October 11, 1988
AHW/88/141/ETS

The USNRC has asked 11 questions regarding the cask supports and ISO container for the NAC-1 (NFS-4) cask amendment request, submitted by Nuclear Assurance Corporation (NAC) on May 25, 1988. The answers to these 11 questions are attached. These answers show that with several modifications to the cask support system (detailed in the attached answers to the USNRC questions), the supports can sustain a 2 g load factor. The g-load requirement for the cask support system is 2 g in the longitudinal, lateral, and vertical directions, applied simultaneously. The analyses performed by NAC, as explained in the attached answers, show that the supports meet this requirement. It has been noted that the 2 g load factor only applies to truck trailers with air ride suspensions; the Fontaine drop-frame trailers specified in the license drawings contain air ride suspensions and this fact has been verified by NAC.

NRC Comments - NAC-1 Cask Supports

Nuclear Assurance Corporation requested an amendment to Certificate No. 71-9183 for the NAC-1 Cask (Ref. No. 1) to incorporate: (1) drawing Nos. NAC-347-586 F2 and NAC-347-586 F3 of the ISO Container Configuration; and (2

Fuel Movement Project
Cask Support - NAC-1

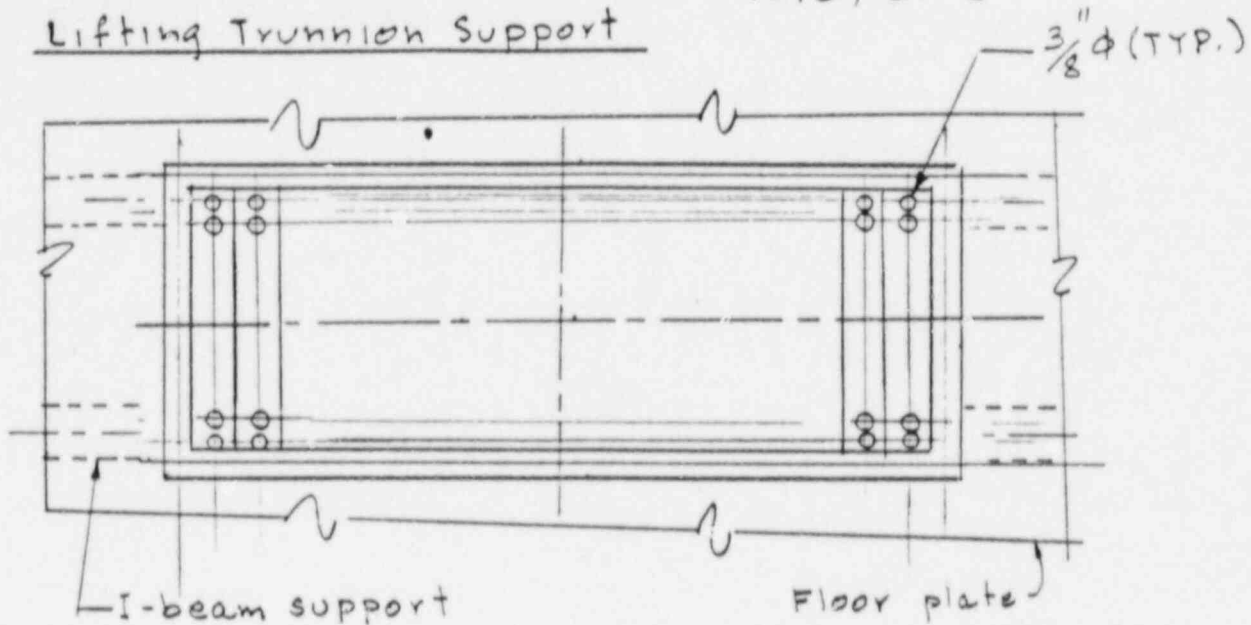
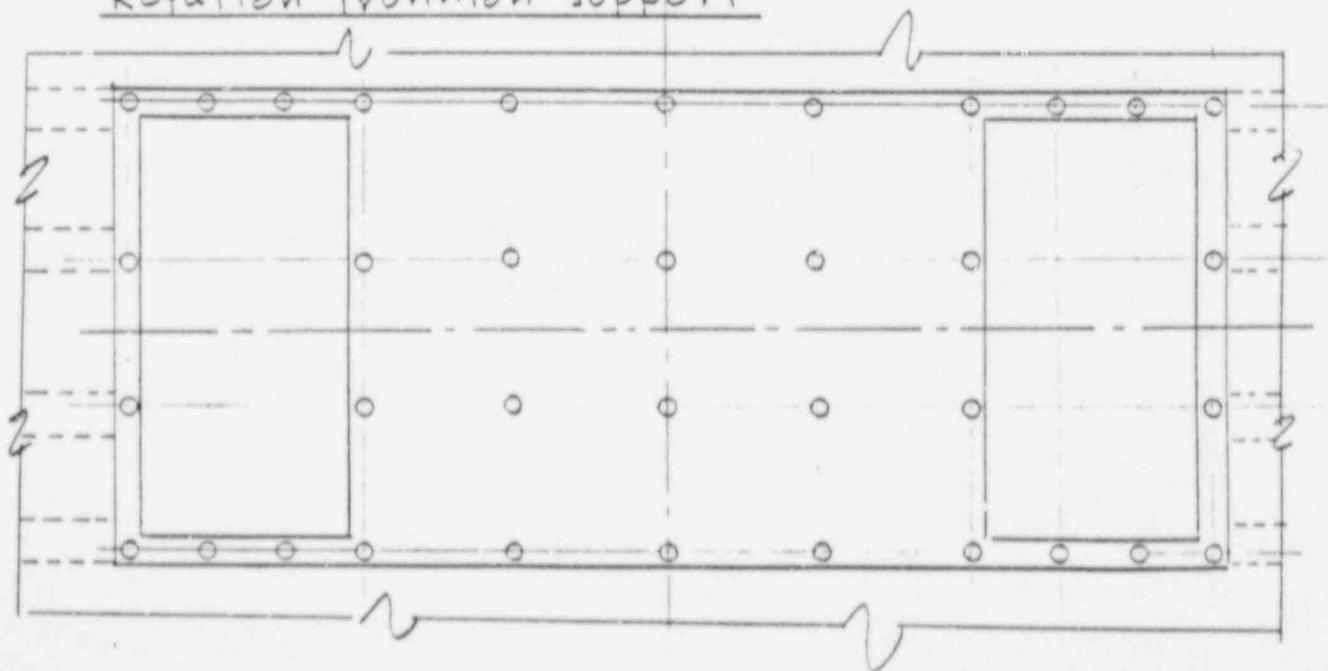
The modifications to the cask support system essentially consist of additional bolts through the cask supports and base plate into the ISO container floor beams so that credit for the welds of the base plate to the container floor is unnecessary. The welds of the base plates to the container floor have been increased to 1/2-inch for the rotation trunnion support and 3/8-inch for the lift trunnion support for conservatism, but these welds are not used in the analyses because welds and bolts are not considered to function simultaneously. The bolt patterns used in the analyses are shown in the attached sketches and also in the license drawings. Additional bolts are shown on these sketches that are not used in the analyses but have been included in the hardware for conservatism.

NAC-1 Cask
Evermaster ISO Container

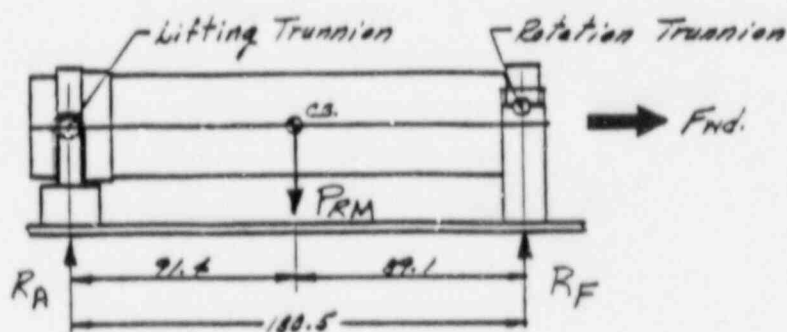
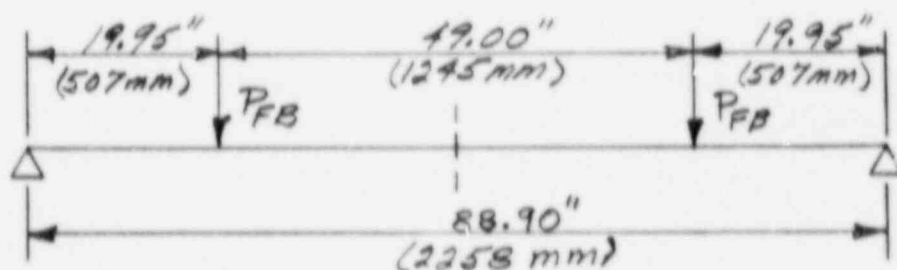
Show how the channel cross members are supported for both the Adamson and the Evermaster containers. Provide an analysis of the load carrying capability for both containers.

The floor cross-members are I-beams for the Adamson containers and channels for the Evermaster containers. An analysis of the load-carrying capability of the cross-members is provided by a beam analysis and by a bolt bearing and shear-tearout analysis. Additionally, the containers have each been load tested per the American Bureau of Ships (ABS) requirements, including a 2.0 g vertical floor load.

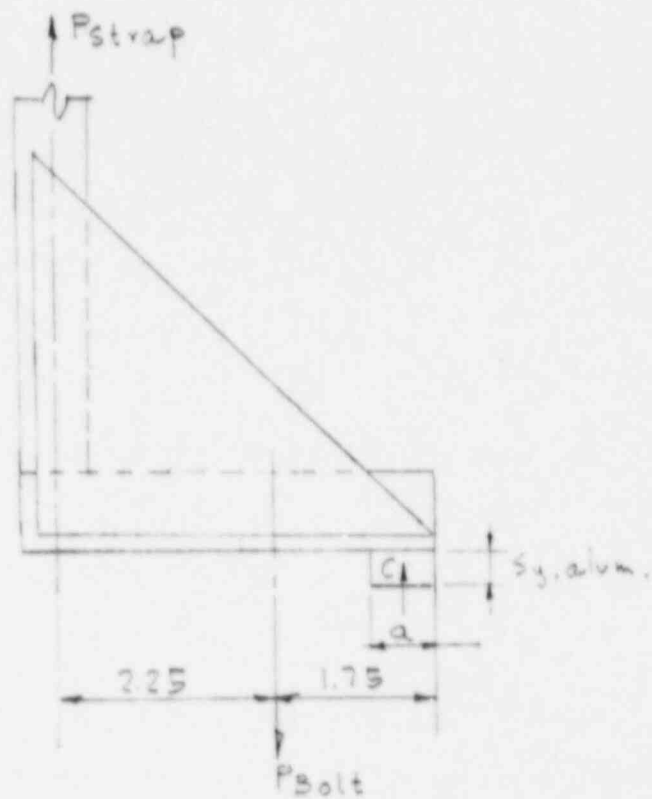
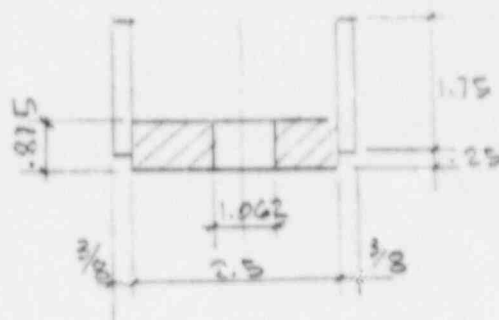
The equation used to calculate the stress of the aft support assembly lug plate is not applicable to the loading and support condition. Show that the combined stiffnesses of the lug and gusset plates are adequate to transfer the strap force (which is applied eccentrically on the lug plate to its center where the connection bolt is located).

The Aft Support assembly lug plate is redesigned to incorporate a 2.5-inch thick block of 6061-T6 aluminum alloy, which is welded to the strap and to the lug plate. A 6.0-inch long, 1.00-inch diameter, SAE J429e, Grade 8 bolt ($S_u = 150$ ksi, $S_y = 130$ ksi) is required. The detailed analysis is provided on the following pages.

Fuel Movement Project

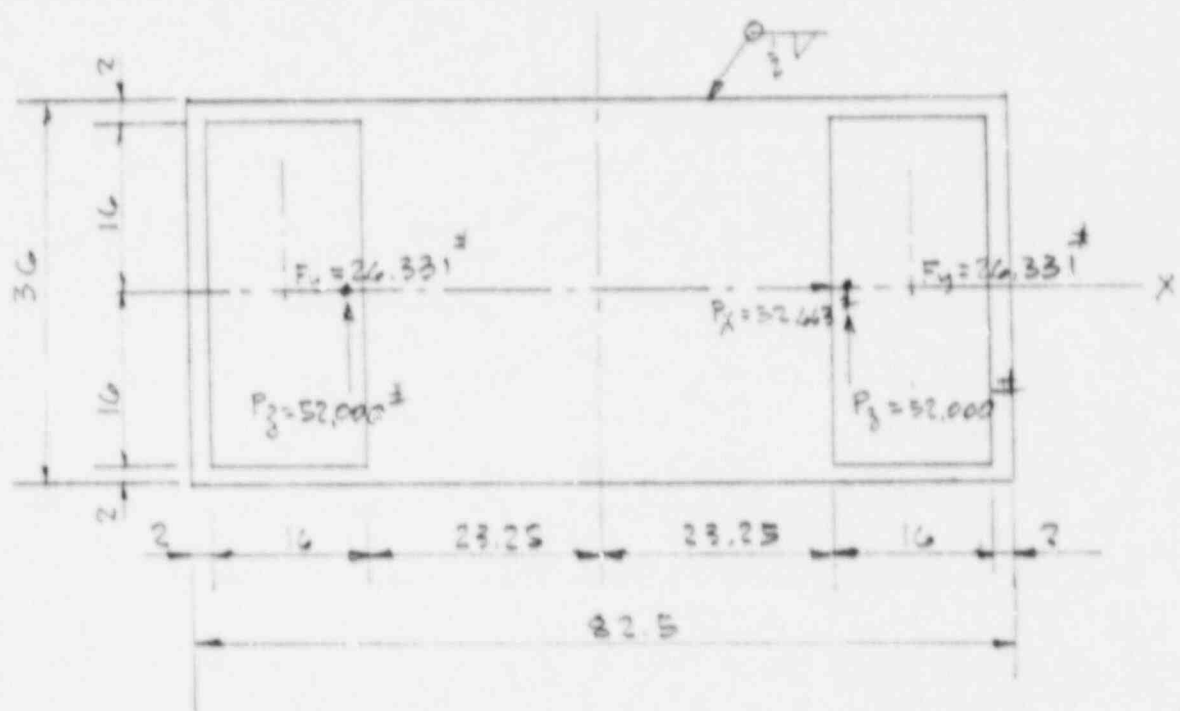
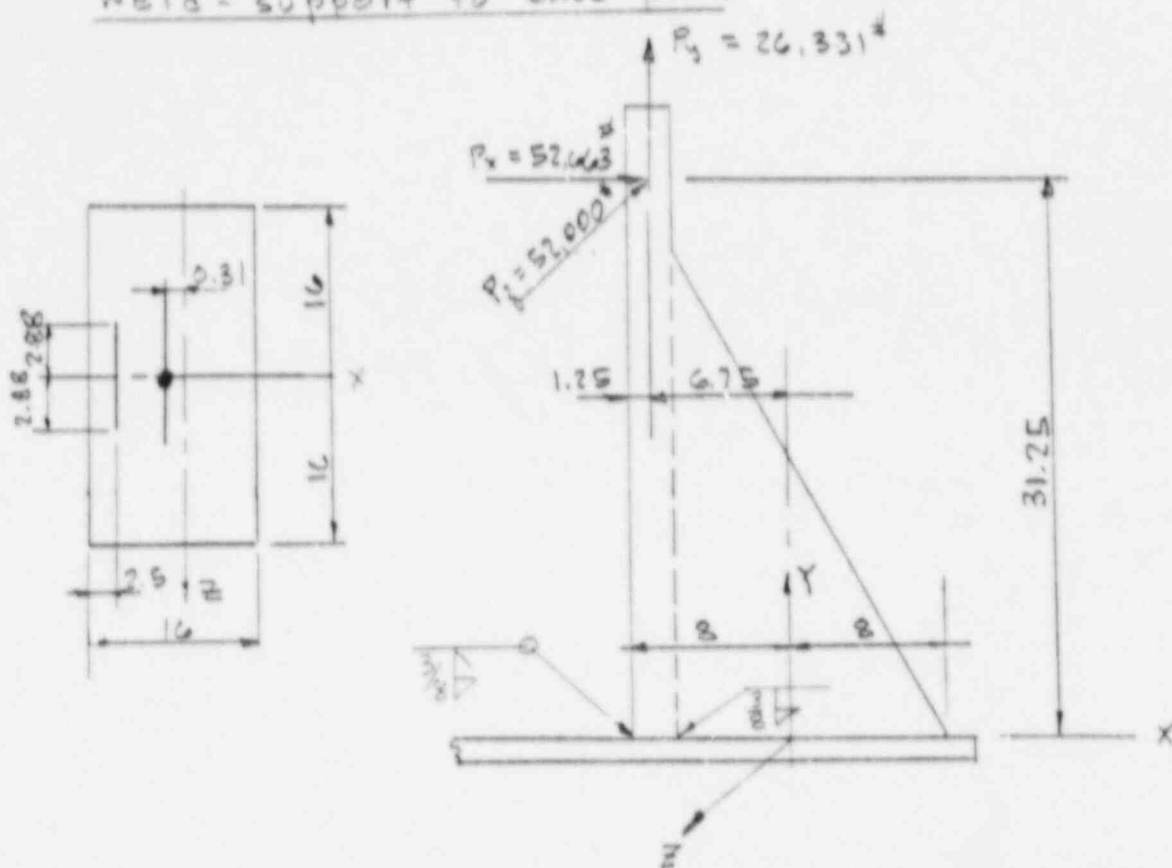
The longitudinal tie-down force is acting alone on the forward support as discussed on page 1 of the Fuel Movement Project. Therefore, the longitudinal load on pages 27 and 28 should be doubled. Revise the analysis on pages 29, 30, 31 and 32 to account for the increased longitudinal force.

The analyses on pages 27 through 31 are for one support, so that the longitudinal force used in the analyses is correct. The longitudinal force to be used for the analysis of the base plate weld on page 32 should be doubled to 104,000 pounds.

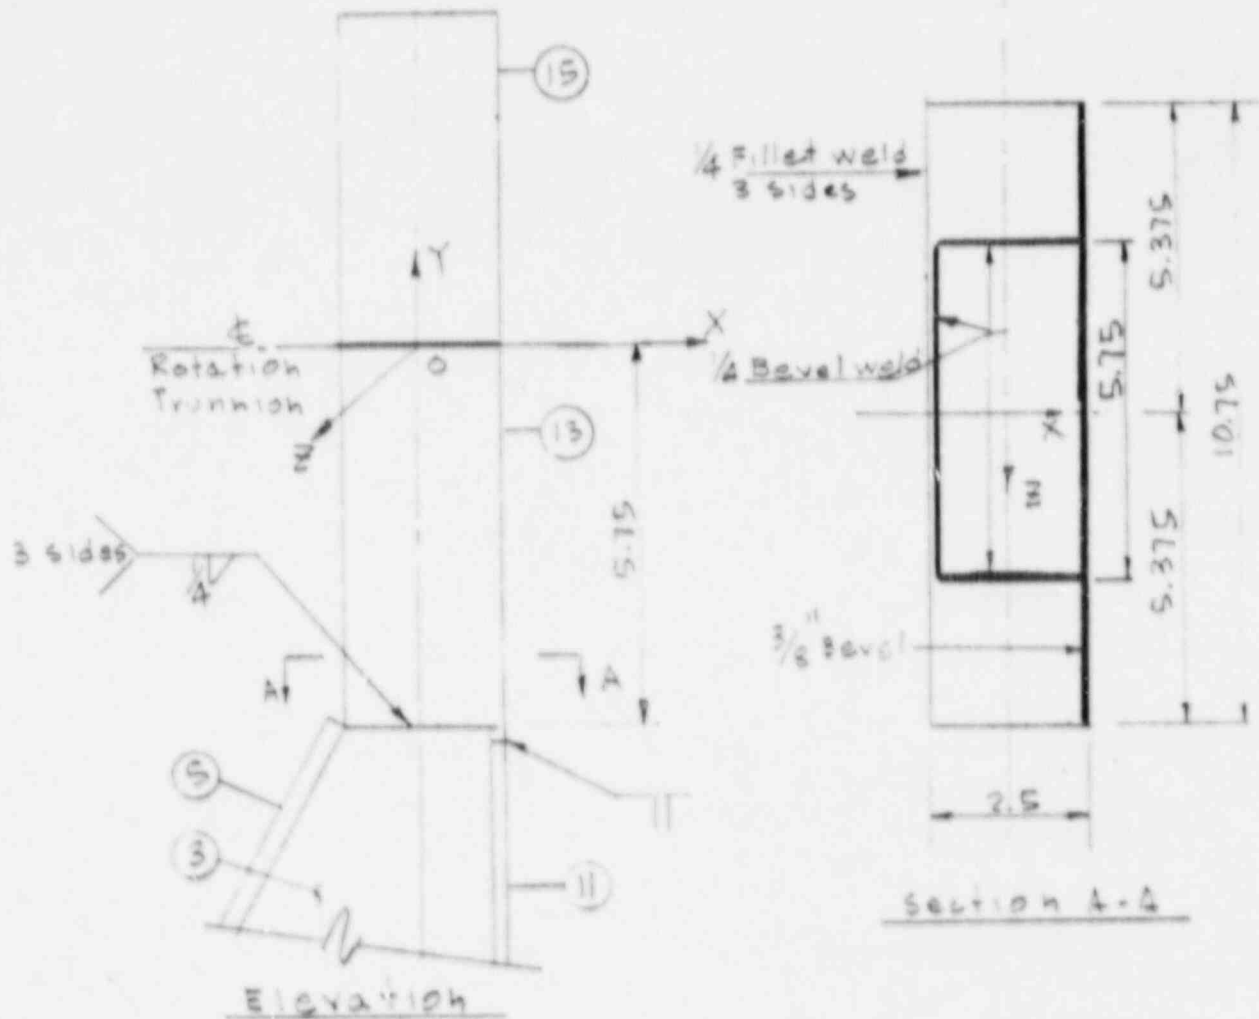
It appears that the same weld may have been used to resist upward, longitudinal, and lateral loads in separate calculations (pages 27, 28). Provide a design sketch to show all the welds and calculate the stress based on combined loads.
